HANNAH RIDGE AT FEATHERGRASS FILING NO. 5

CONSTRUCTION PLANS

HANNAH RIDGE AT FEATHERGRASS FILING NO. 5, 6 & 7 OVERLOT GRADING AND EROSION CONTROL PLAN			
DESIGNED BY	KRC	SCALE	DATE 10/12/18
DRAWN BY	KC	(H) 1" = 50'	SHEET 3 OF 11
CHECKED BY		(V) 1" = NA	JOB NO. 1116.05

STORM SEWER RUN 1

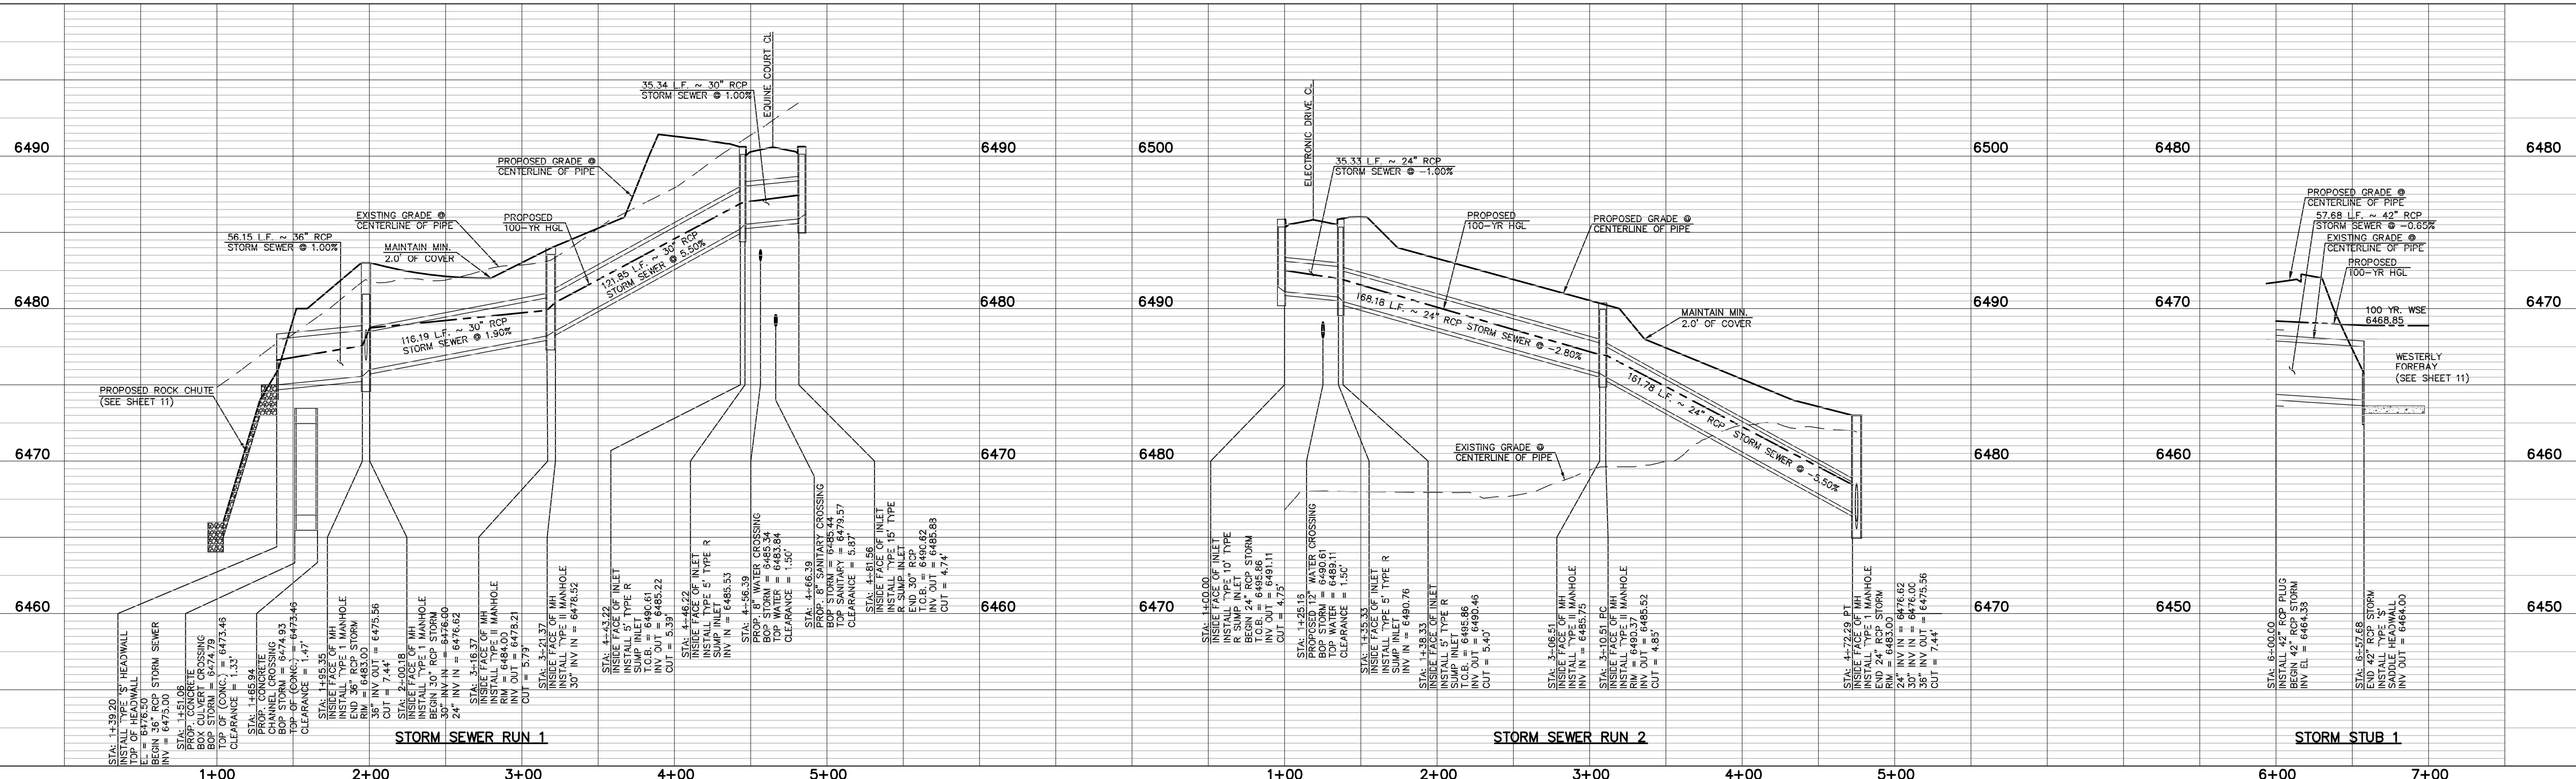
Call out Public Drainage easement.

HANNAH RIDGE AT FEATHERGRASS FIL. 5			
CONSTRUCTION DRAWINGS			
DETENTION FACILITY NO. 1			
POND PLAN			
DESIGNED BY	MAW	SCALE	DATE 10/12/18
DRAWN BY	ESO	(H) 1"= 30'	SHEET 9 OF 11
CHECKED BY	(V) 1"= 3'	JOB NO.	1116.05

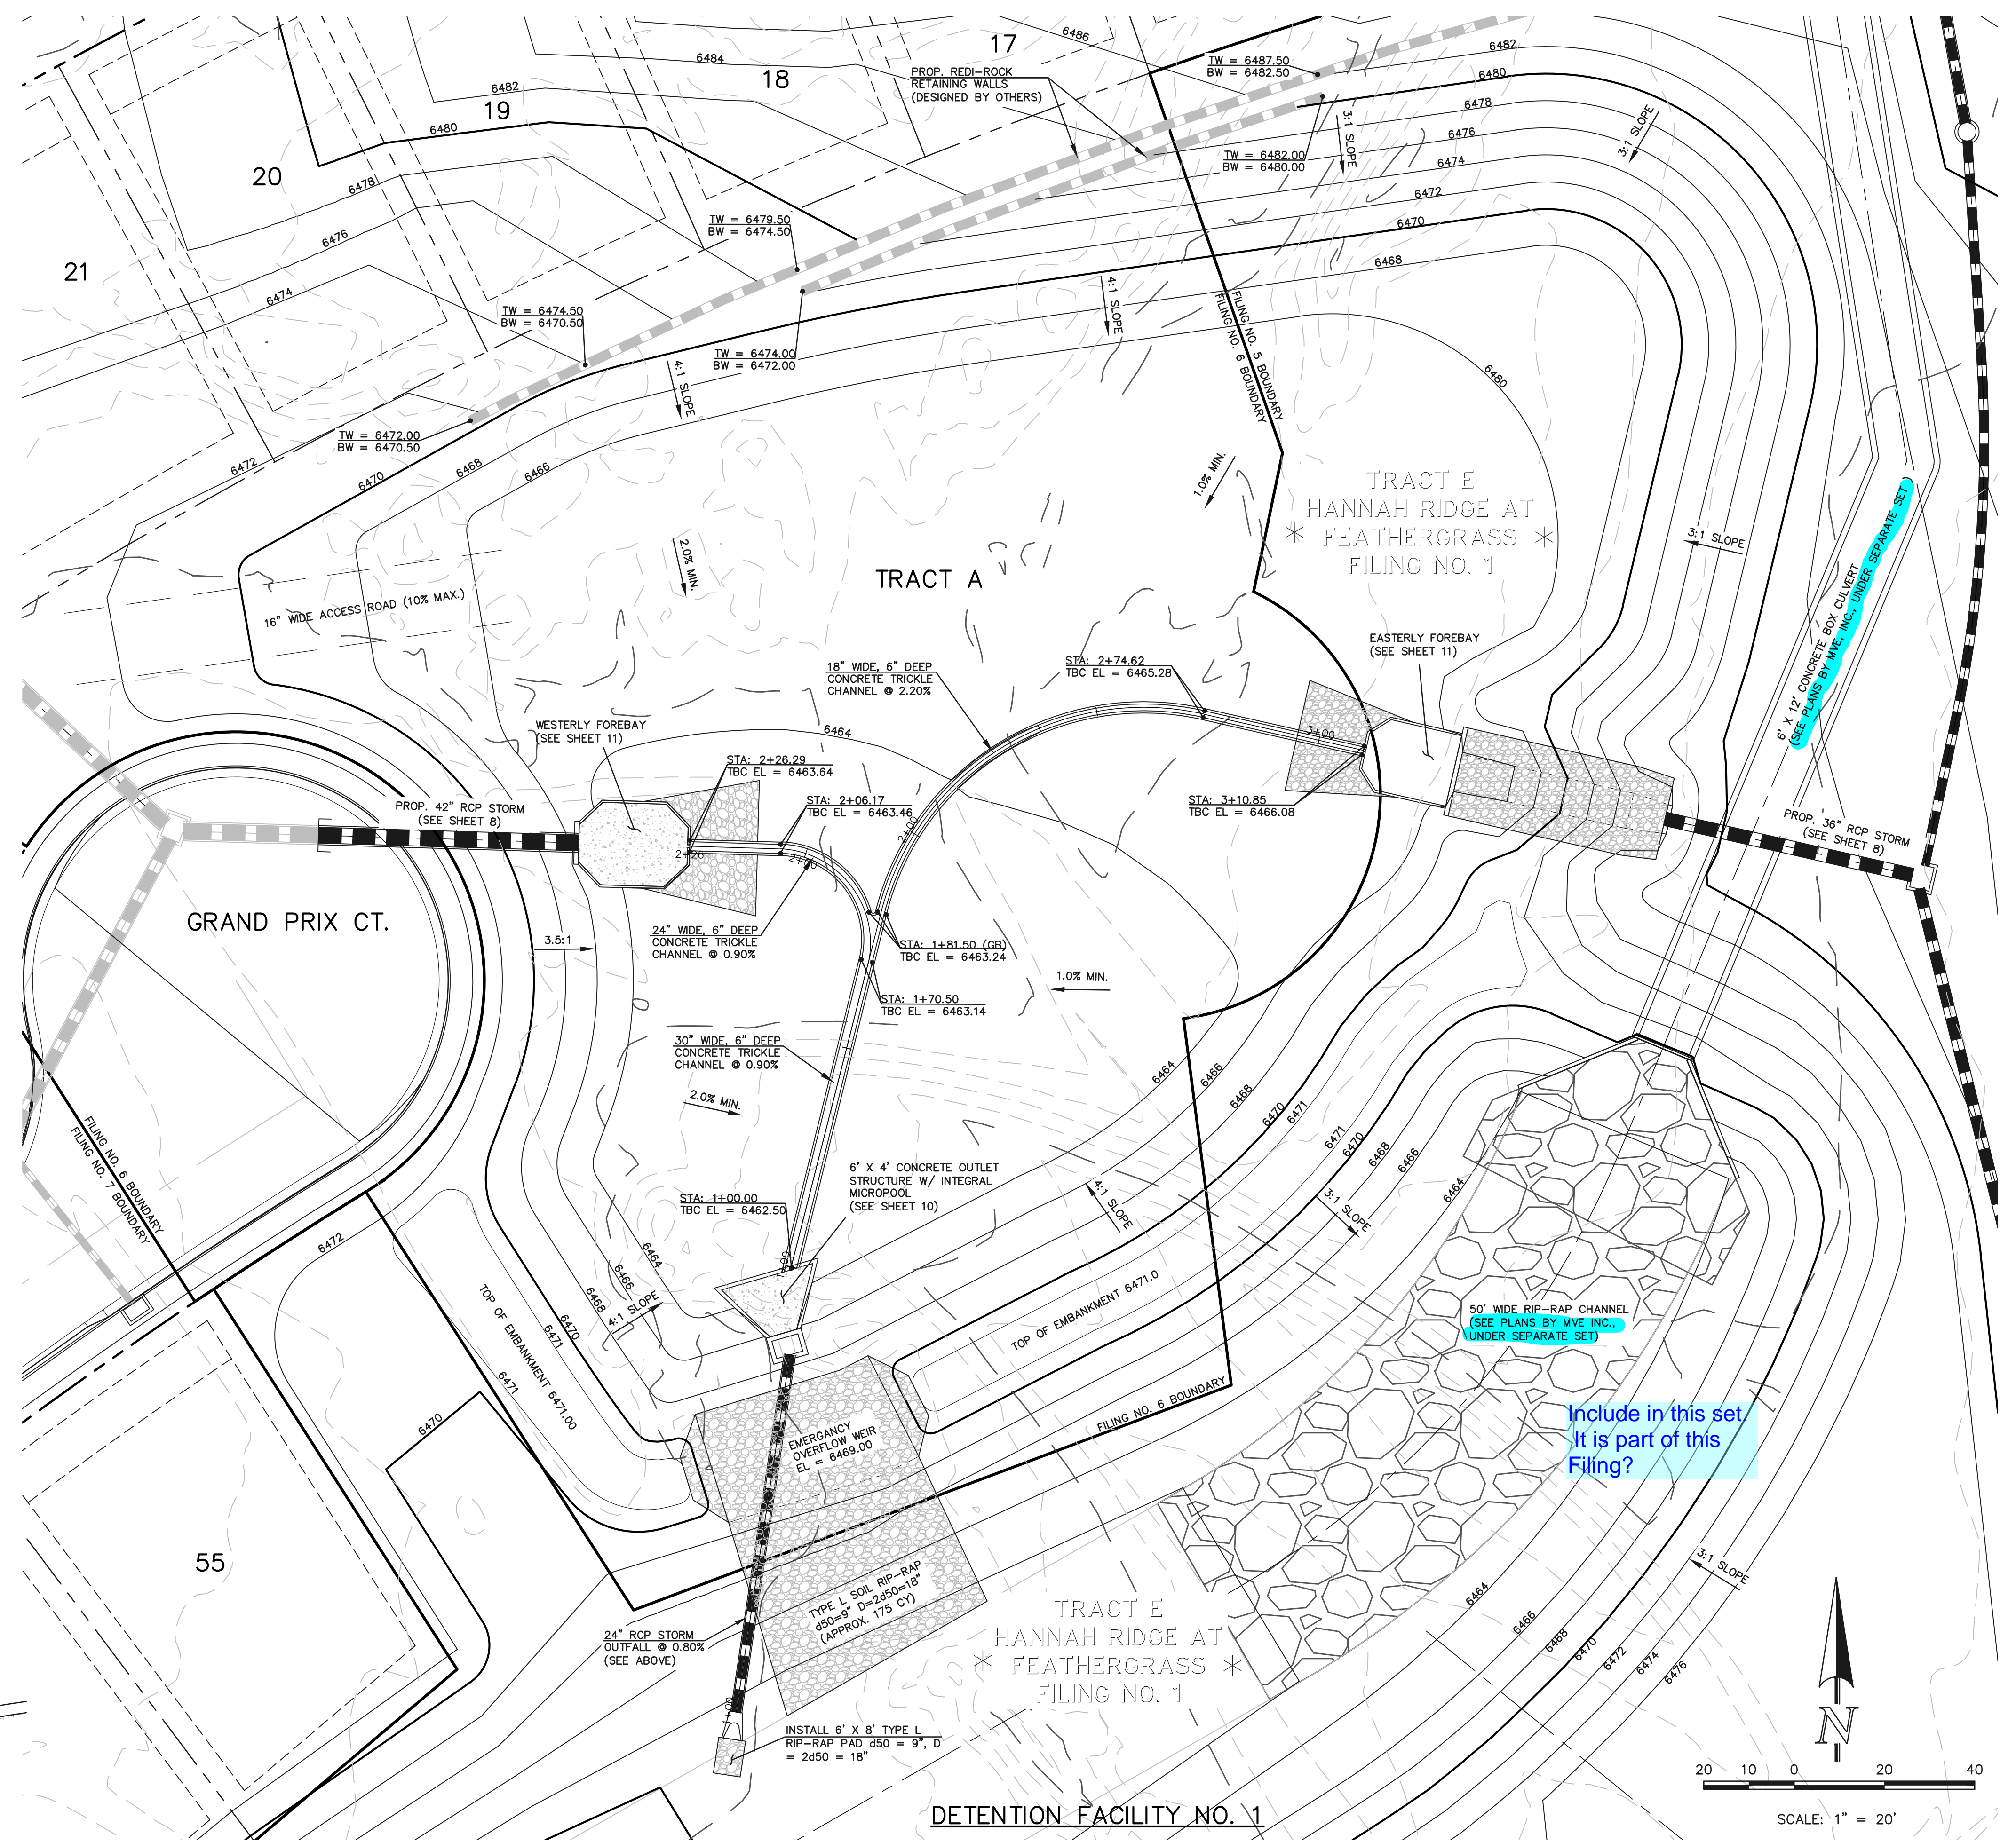
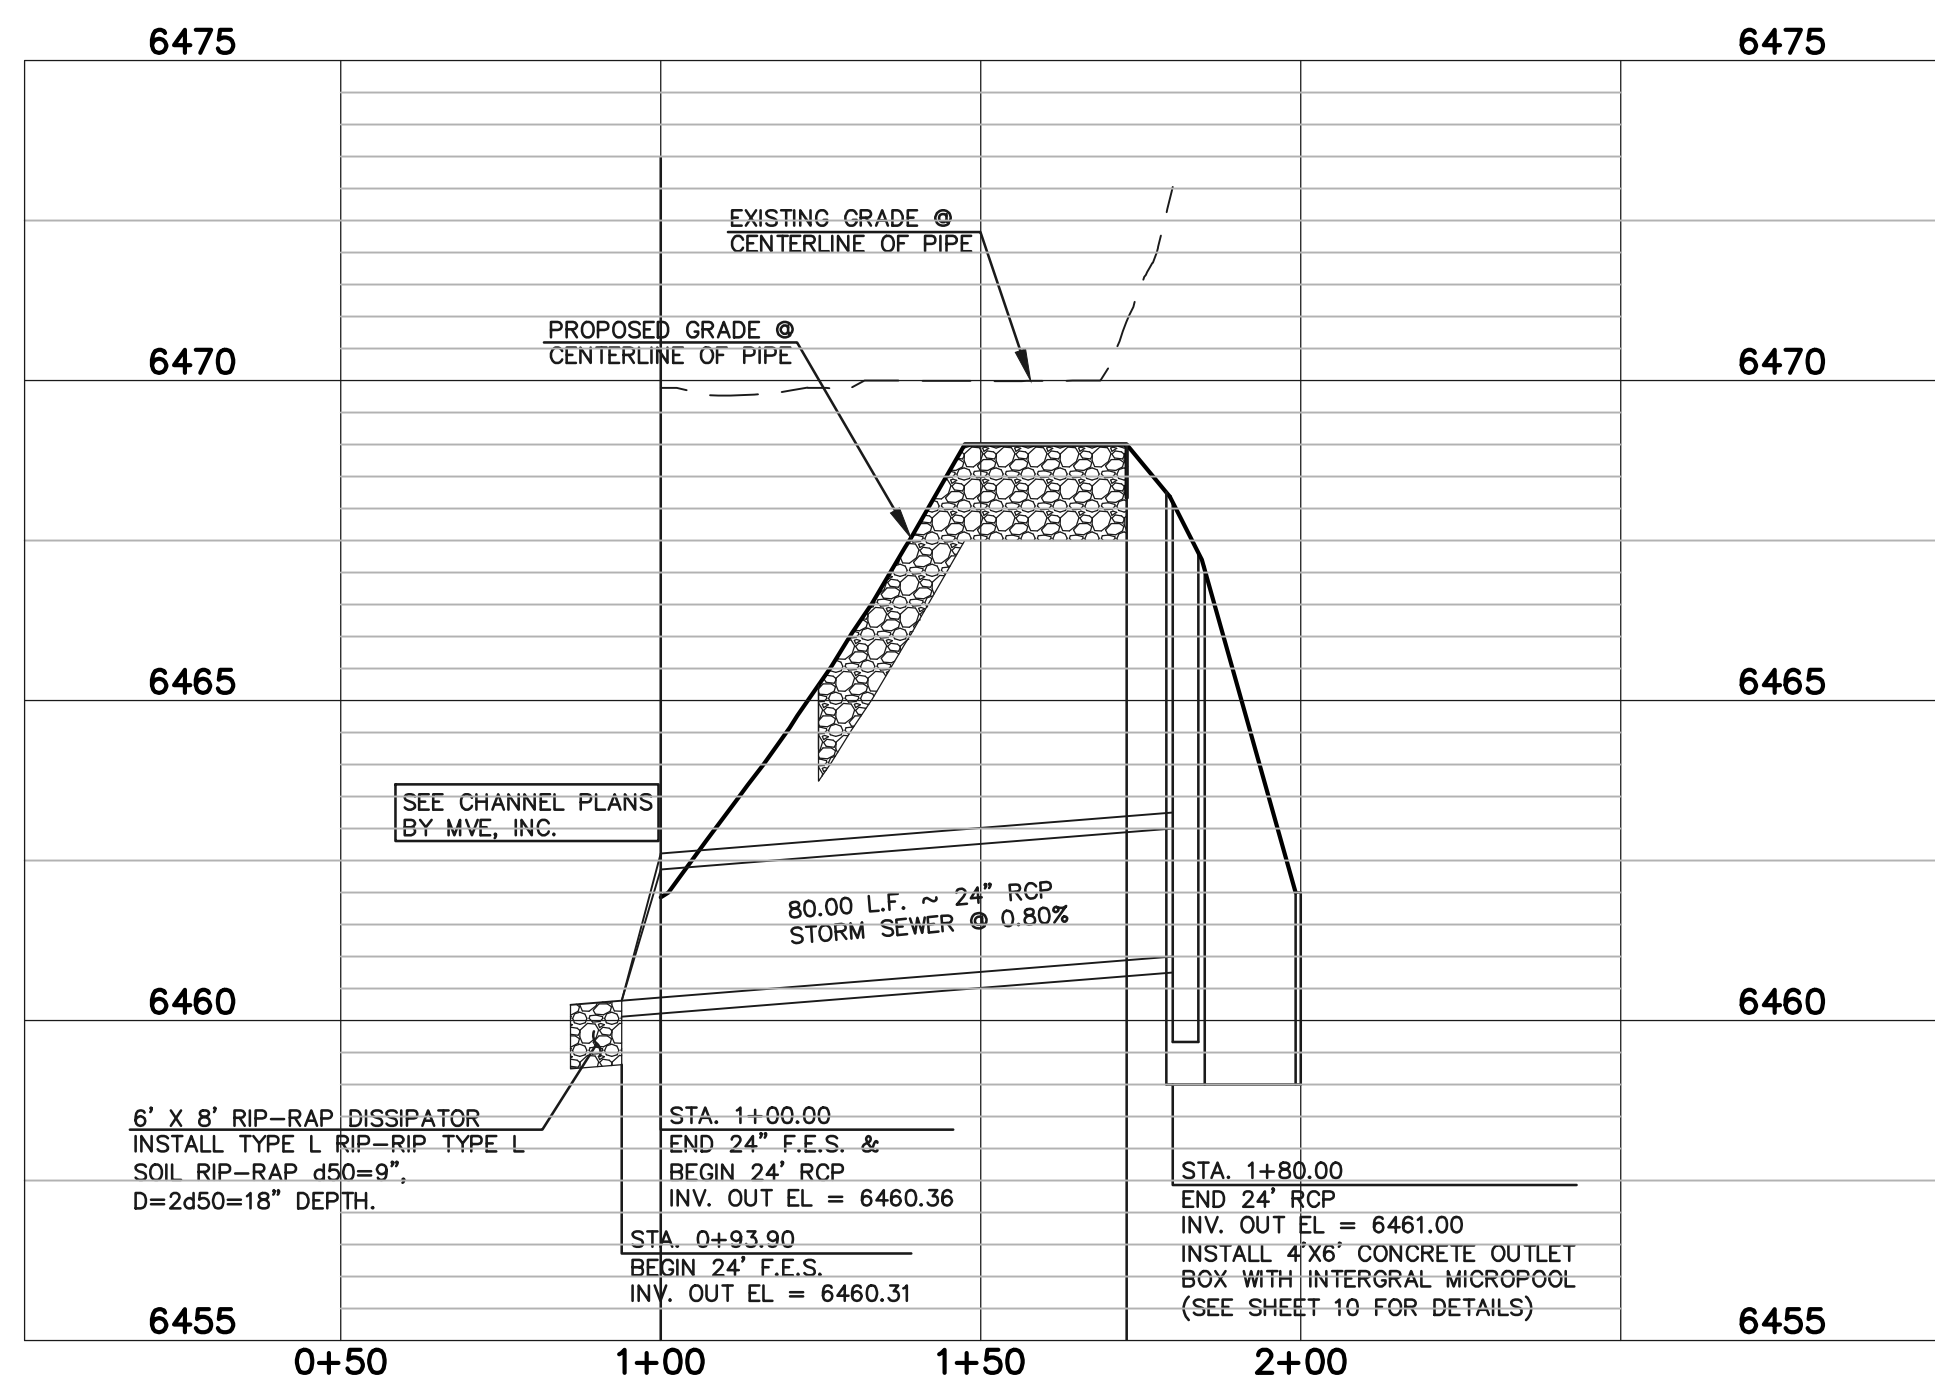
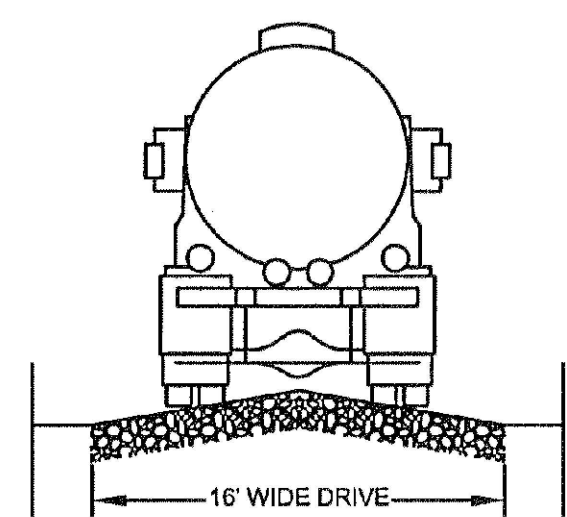
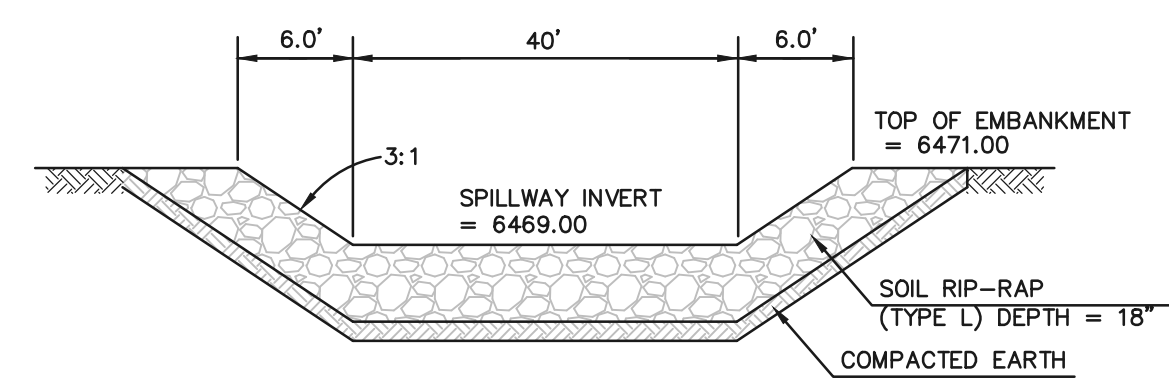
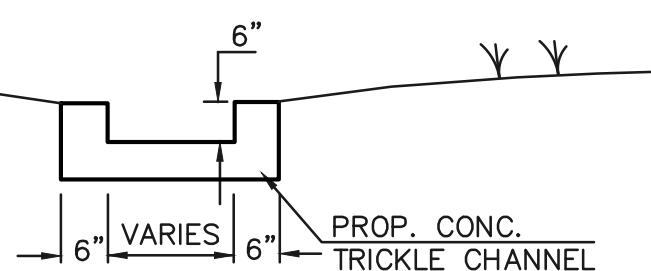
Include in this set
It is part of this
Filing?
